# HISTORIC LANDMARK COMMISSION APPLICATION FOR A CERTIFICATE OF APPROPRIATENESS DECEMBER 16, 2019 C14H-2007-0040 PARRISH-FLEMING HOUSE 1410 NORTHWOOD ROAD

### PROPOSAL

Replace windows.

Google streetview photo - 2014

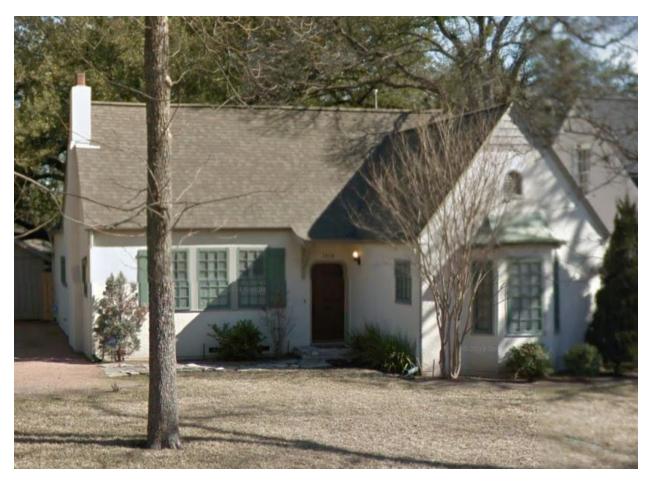
The applicant has already replaced the windows in the house. The house had 1:1 windows with 6:6 wooden screens over them; the replacement windows are 6:6 with no screens.

Evaluation: The original windows on the house were replaced with windows that do not match the original configuration.

Evaluation: The original windows were 1:1 with 6:6 wooden screens; the applicant replaced the windows with 6:6 windows and no screens.

Evaluation: The applicant states that the existing windows were deteriorated beyond repair, but should have conducted a window-by-window survey to determine which, if any, of the windows could have been repaired rather than replaced. In any replacement, the replacement material should match the historic material. In this case, it did not.

No recommendation. This is a case for the Commission to decide the appropriate remedy, which may include accepting the current condition, additional reprimands, requiring the applicant to take out the current windows and replace them with 1:1 windows with 6:6 screens as originally on the house, referring the case to the appropriate department for prosecution, or recommending against the applicant's application for a tax exemption for the historic landmark. Staff believes this was an honest mistake by the applicant, but is still very disturbed by the change in the appearance of this historic landmark and recommends some sort of action at the Commission's discretion.
